HOLDOVER/REVISED**PLANNED UNIT DEVELOPMENT
& SUBDIVISION STAFF REPORT****Date: April 5, 2012****DEVELOPMENT NAME** Pinehurst Subdivision, Re-subdivision of Lot 3, Block 116**SUBDIVISION NAME** Pinehurst Subdivision, Re-subdivision of Lot 3, Block 116**LOCATION** Southern terminus of Schaub Avenue**CITY COUNCIL
DISTRICT** District 6**PRESENT ZONING** R-1, Single-Family Residential District**AREA OF PROPERTY** Subdivision 2 Lots / 0.2 ± acres
Planned Unit Development 2 Lots / 0.2 ± acres**CONTEMPLATED USE** Planned Unit Development approval to allow reduced lot sizes and reduced lot widths in a proposed subdivision.**TIME SCHEDULE
FOR DEVELOPMENT** Immediately**ENGINEERING
COMMENTS**

Revised for the May 5th meeting:

SITE PLAN

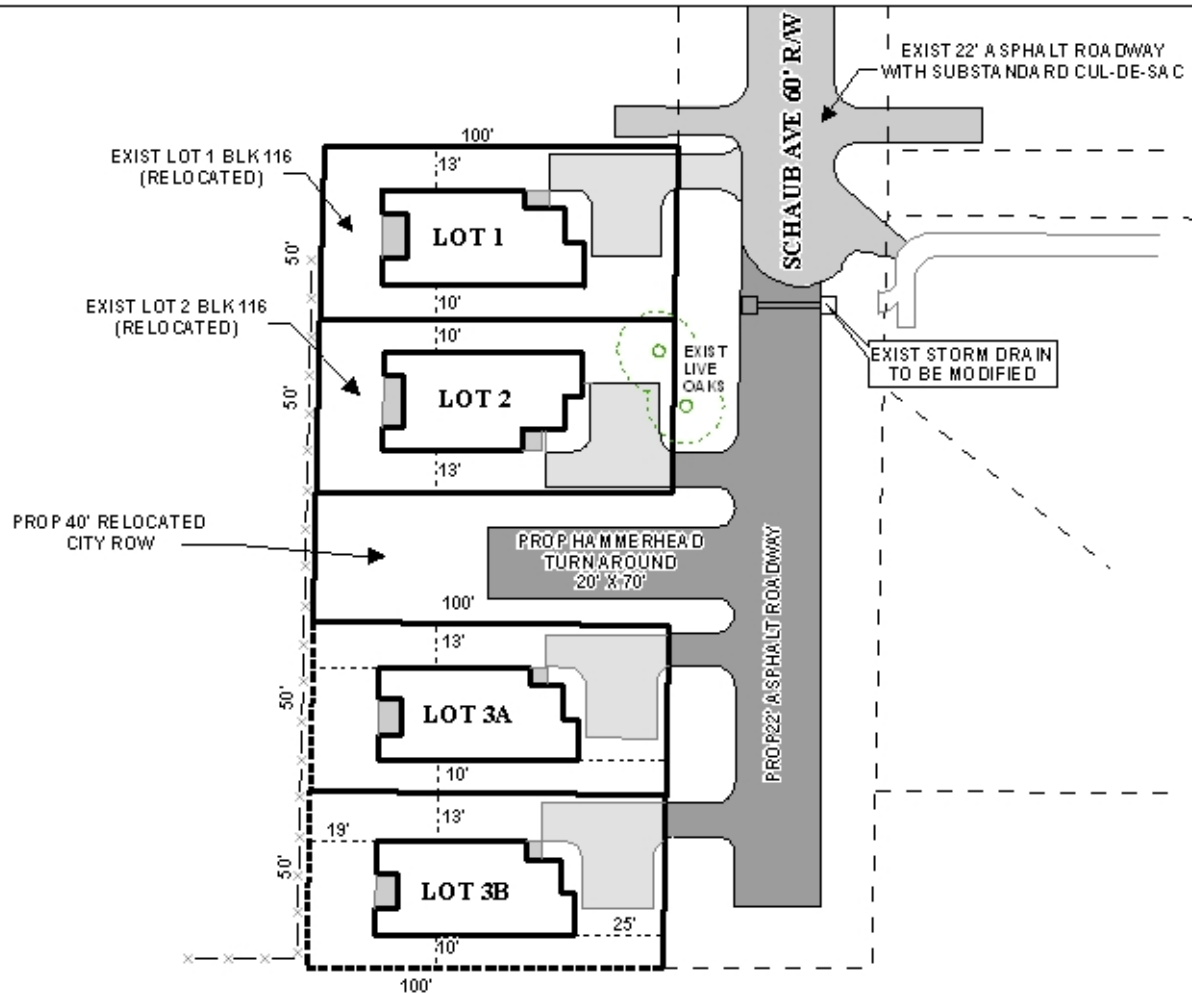
Driveway number, size, location and design to be approved by Traffic Engineering and conform to AASHTO standards. The driveway to Lot 1 from the proposed hammerhead should be 10' to match the proposed driveways for the other three lots.

Revised site plan removes all driveways from proposed hammerhead and are illustrated as a standard width. Driveway number, size, location and design to be approved by Traffic Engineering and conform to AASHTO standards. Two (2) Type 4 object markers, per MUTCD standards, will be required (one at the end of each roadway).

The turnaround (preferably the 96 foot diameter cul-de-sac) is to be located at the end of the roadway or within 150 feet of the end of the roadway to limit the backing distance of an emergency vehicle to a maximum of 150 feet.

The applicant submitted a revised narrative and site plan for the applications. The revised site plan depicts four single building sites; however, it illustrates the vacation of an unimproved existing 40-foot street stub right-of-way located to the North of the proposed 4-lot development. Typically, property owners along each side of the existing right-of-way receive one-half of the vacated right-of-way. The applicant is proposing to include all of the 40-foot right-of-way and proposes to create a new 40-foot right-of-way between proposed lots 2 and 3A to provide a hammerhead to comply with the International Fire Code.

No information was provided regarding provision of storm water detention facilities, as requested. Therefore, compliance with the stormwater ordinance and the placement of a note stating so would be required on the Final Plat.

- 1) illustration of a 25-feet minimum building setback along Schaub Avenue on the Final Plat;*
- 2) placement of a note on the Final Plat stating each lot is limited to one curb cut to Schaub Avenue to include the modifications suggested by Traffic Engineering (Driveway number, size, location and design to be approved by Traffic Engineering and conform to AASHTO standards. Two (2) Type 4 object markers, per MUTCD standards, will be required {one at the end of each roadway};*

- 3) placement of a note on the Final Plat stating that Lots 2 and 3A be denied direct access to the proposed hammerhead;*
- 4) the provision of the vacation of the existing 40-feet undeveloped right-of-way and the dedication of the proposed 40-feet right-of-way to be dedicated and constructed to comply with City Engineering and Fire Department requirements;*

- 5) placement of a note on the Planned Unit Development site plan stating each lot is limited to one curb cut to Schaub Avenue to include the modifications suggested by Traffic Engineering (Driveway number, size, location and design to be approved by Traffic Engineering and conform to AASHTO standards. Two (2) Type 4 object markers, per MUTCD standards, will be required {one at the end of each roadway);*
